**REGULAR SESSION OF THE ANN ARBOR HISTORIC DISTRICT COMMISSION  
THURSDAY, FEBRUARY 11, 2010 AT 7:00 P.M. SECOND FLOOR, CITY COUNCIL  
CHAMBERS, 100 N. 5<sup>th</sup> AVENUE, ANN ARBOR, MI**

## ANN ARBOR HISTORIC DISTRICT COMMISSION

**ADDRESS:** 517 Krause, Application Number HDC10-009

**APPLICATION:** The applicant seeks HDC approval to add a two-story addition with a shed roof and cementitious board and batten siding on the rear of the house.

Sheet Number: **A-5**

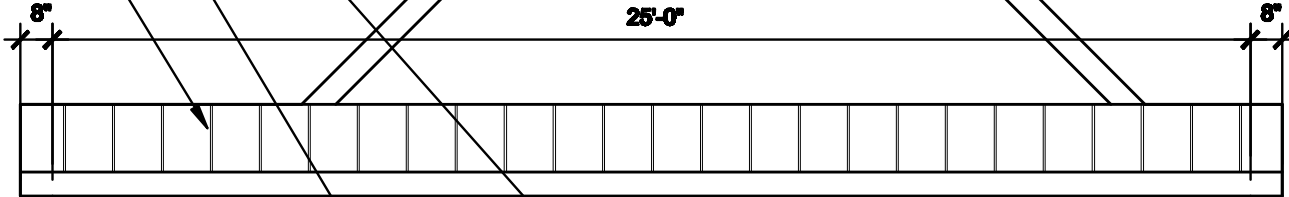
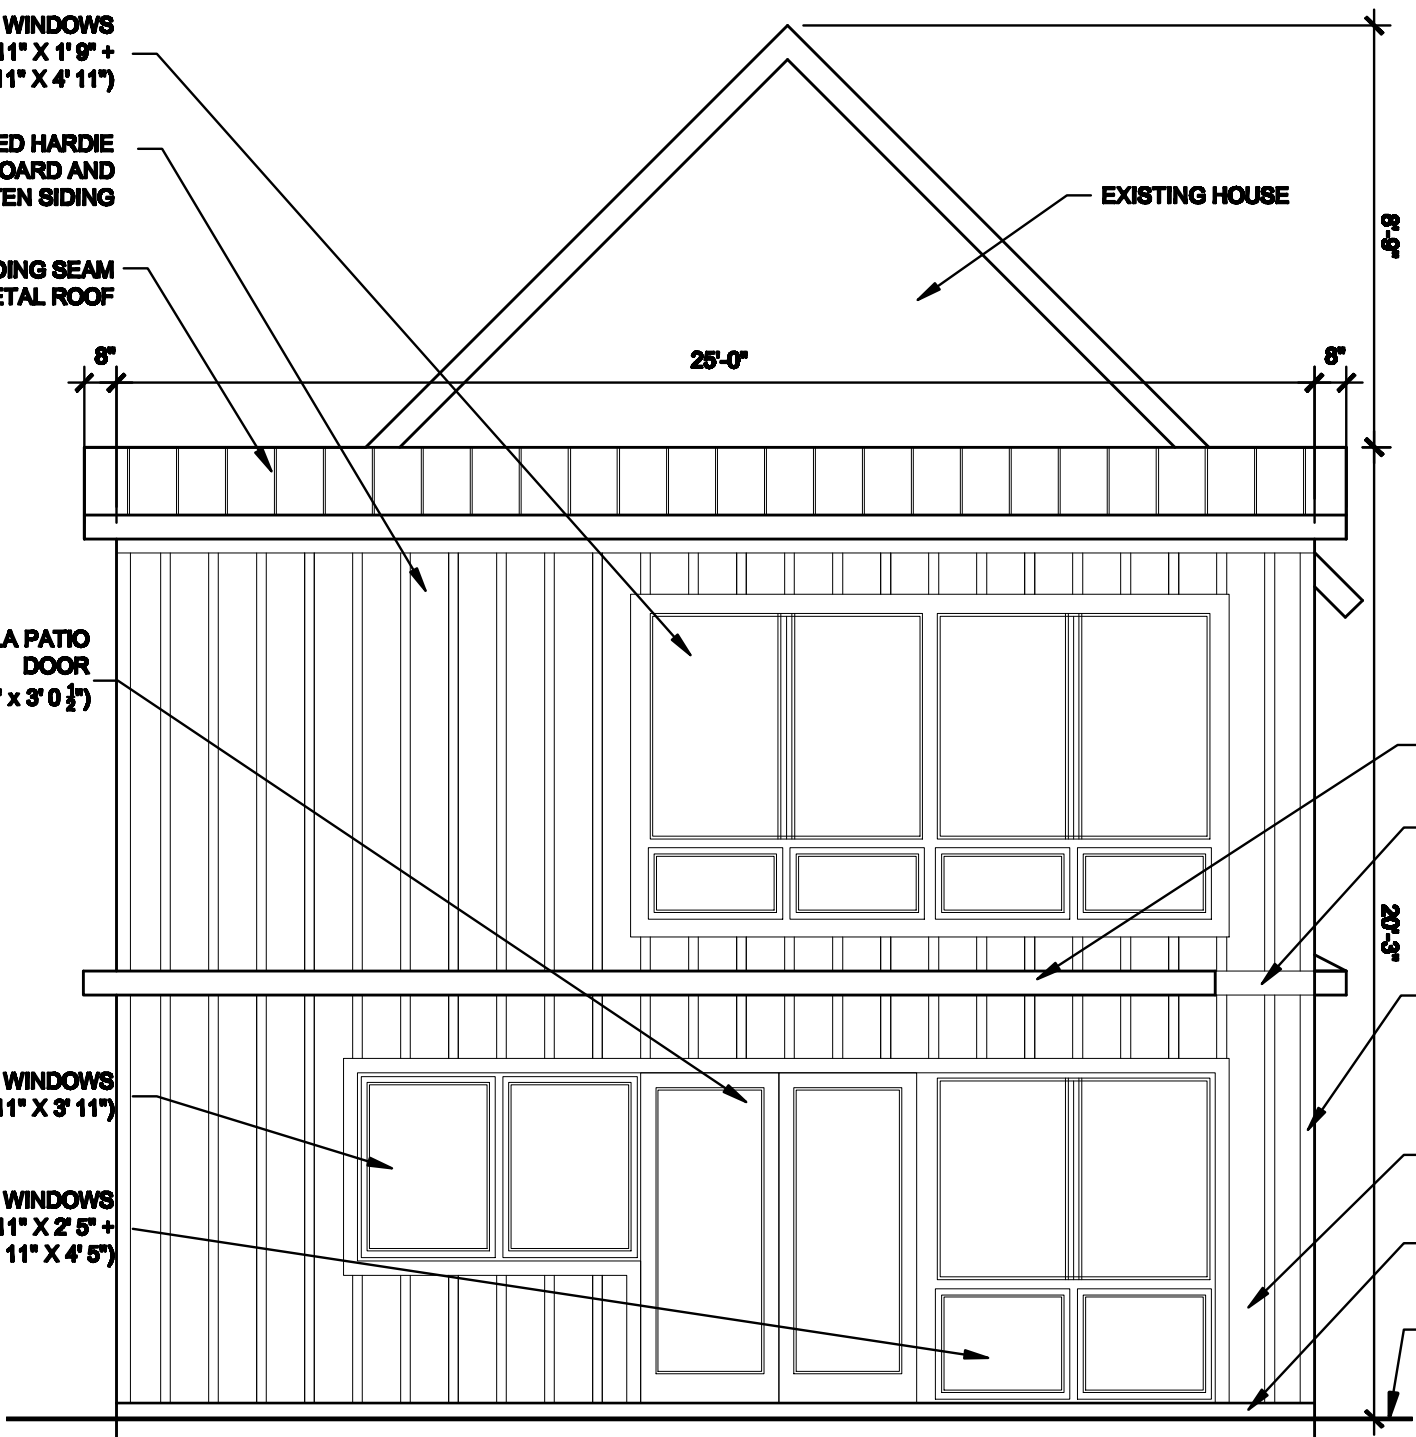
2. The windows on the house are regularly spaced but of various sizes and shapes, including square windows on the front and both side elevations. The square windows proposed for the addition are proportionate to the ones on the side elevations and their placement is such that they align horizontally with existing windows on the side elevations. Three of the four wood windows on the rear elevation are replacements, and the rest on the house are original.

3. Staff feels that this proposed addition is a good example of the Secretary of the Interior's Guideline that states "Design for the new work may be contemporary." The board and batten siding is a very traditional cladding but in this case contributes to the contemporary design of the addition. The standing seam steel roof will only be minimally visible on the first floor connector. The addition would likely look awkward if clad in wood shingles to match the house.

### **7. Remove small window in closet on the back of house.**

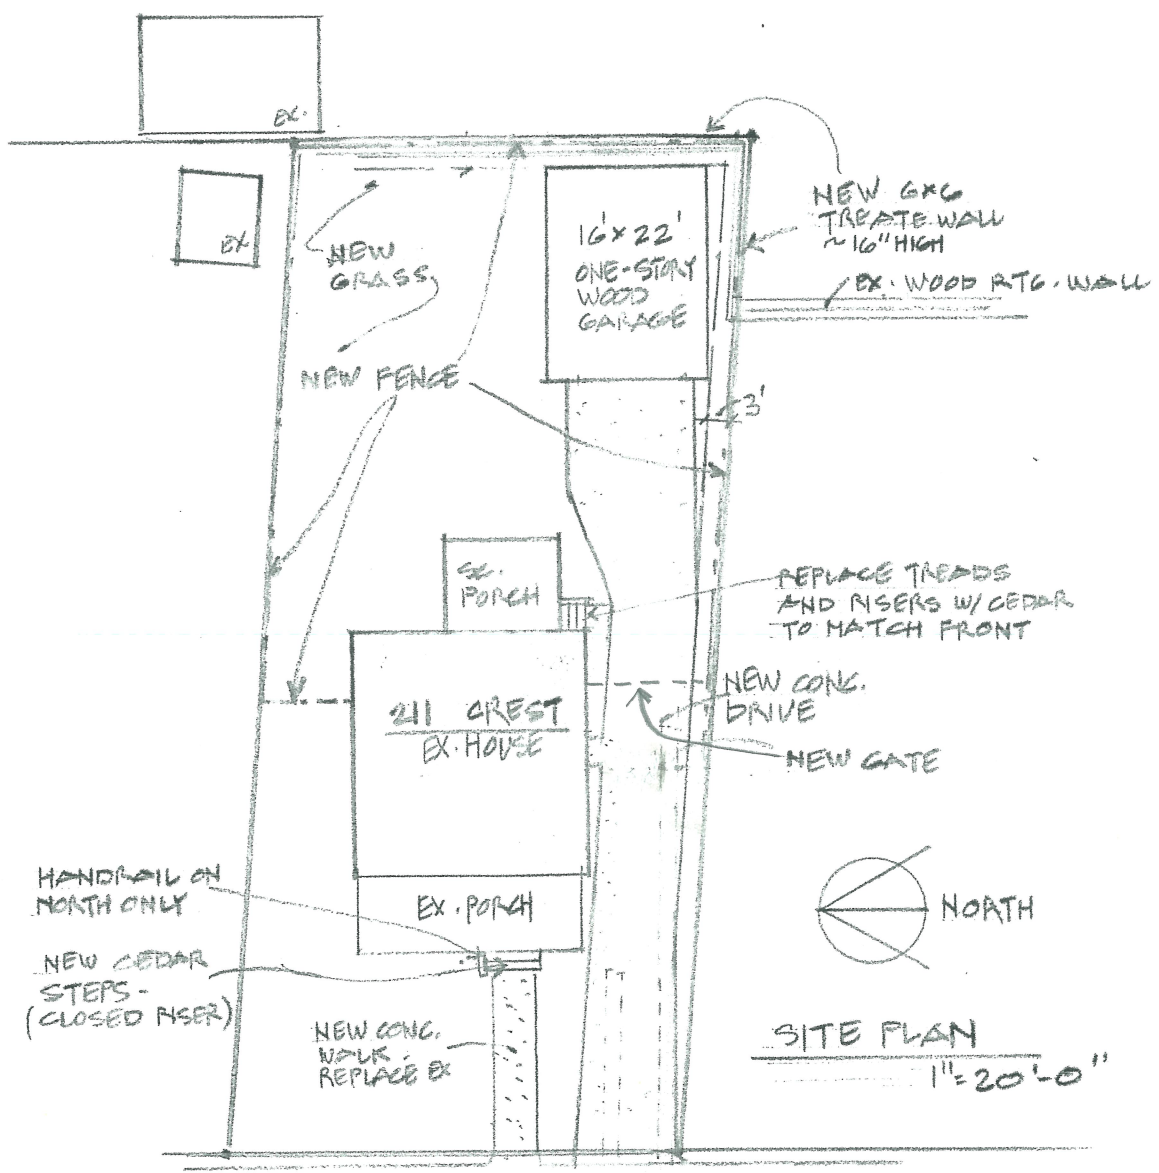
5. The window proposed to be removed on the second floor of the rear elevation is in a closet. Staff has seen other houses of this era with similar square closet windows. Next to the closet is a bathroom that is fairly dysfunctional (the toilet is too close to the tub wall, necessitating sitting a little sideways) and the owners want to combine the two spaces. (See bathroom floorplan.) Pushing the bathtub against one of the outer walls in the combined space will place it either below the rear square window or a larger window on the south wall. The owners desire to remove the rear window to keep it out of the shower and improve the bathroom layout.

I move that the Commission deny the portion of the application at 211 Crest Avenue to remove a window on the rear elevation. The proposed work does not meet *The Secretary of the Interior's Standards for Rehabilitation and Guidelines for Rehabilitating Historic Buildings*, in

SOUTH / EAST ELEVATION • EXISTING. 6/11/09

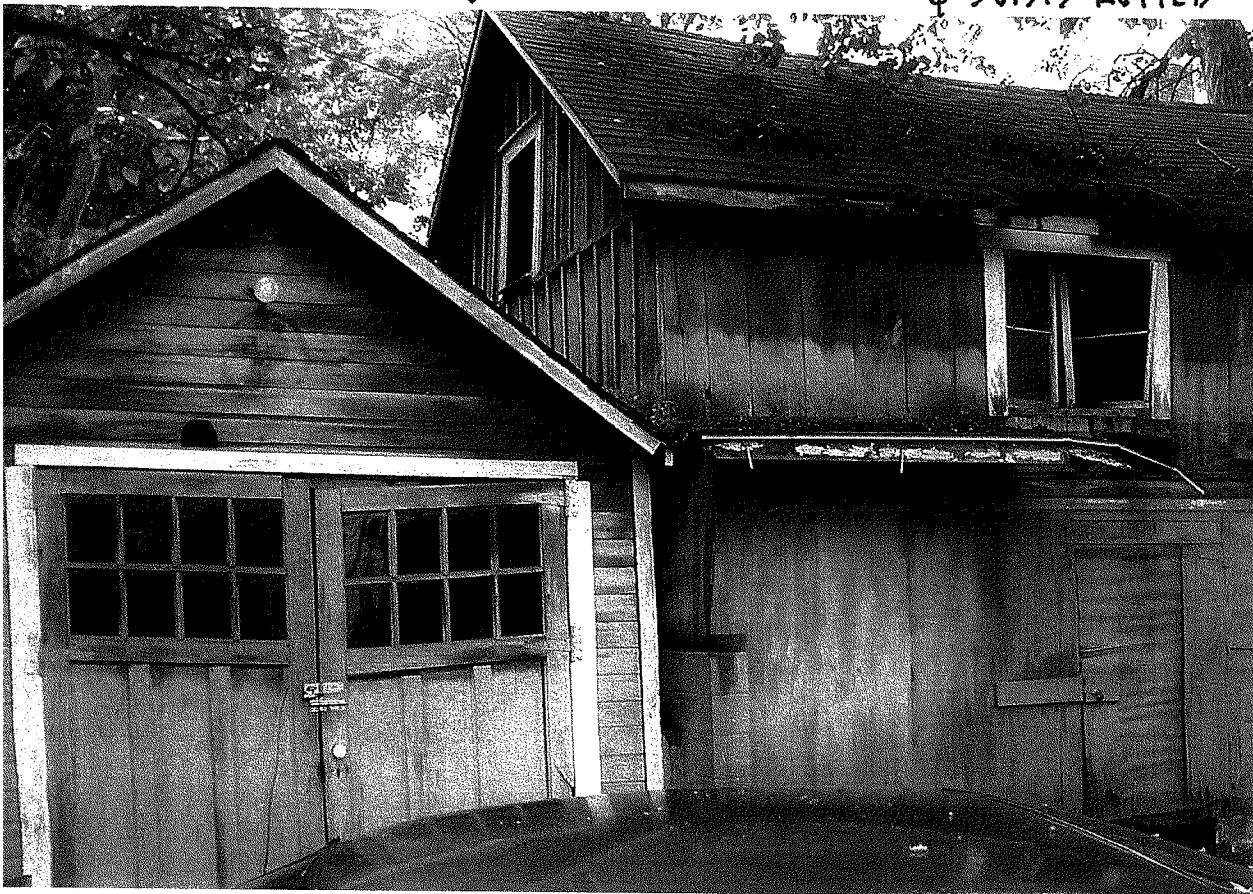
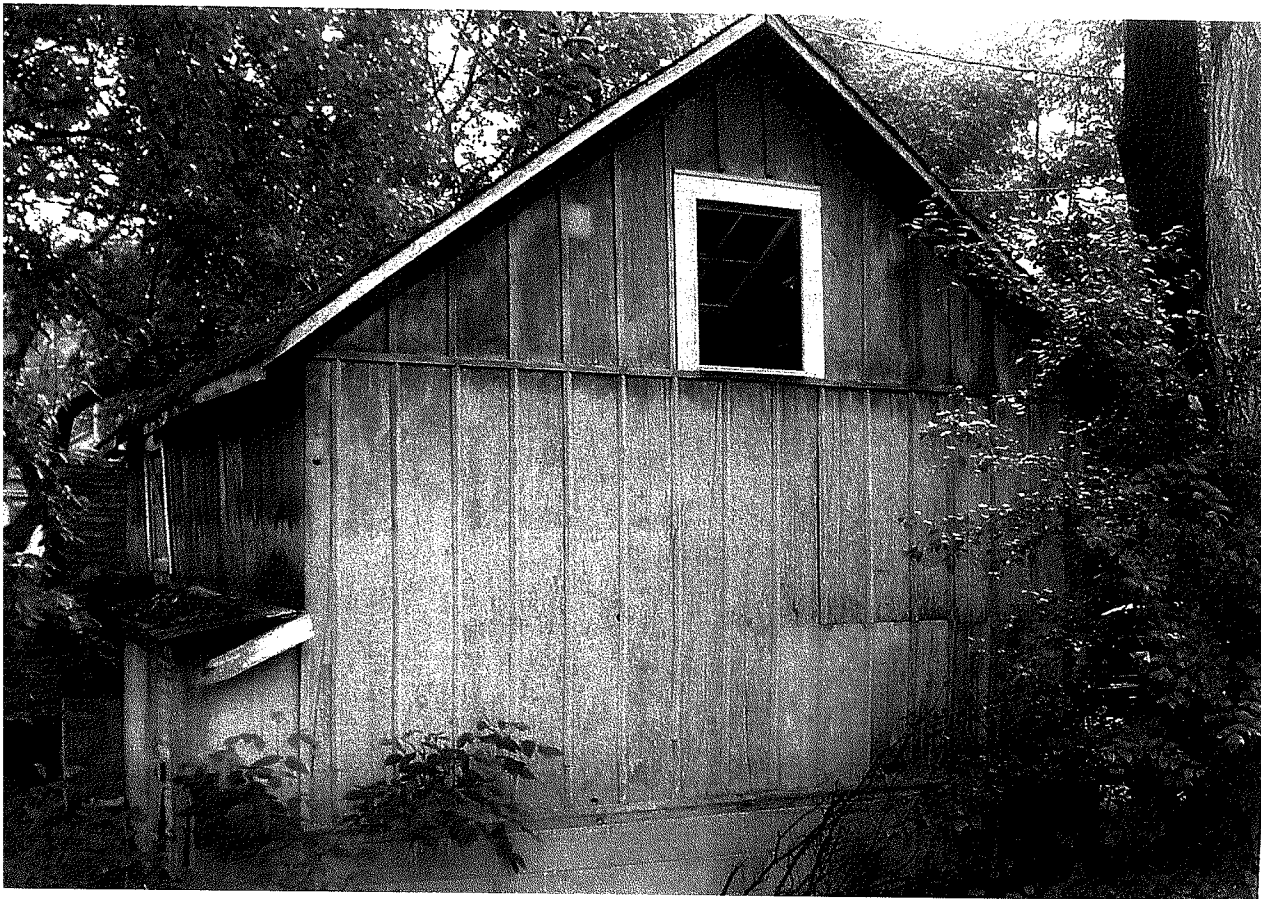
2. Staff visited the site in December and Stafford pointed out the problems. The roof joists are rotted to a point that shoring them with new materials will be inadequate, the bond beam along the front of the structure is more deteriorated than originally thought, and the wall framing is failing. Staff inquired about reusing the siding and Stafford said it's too dry and brittle to remove and reinstall without it falling apart.
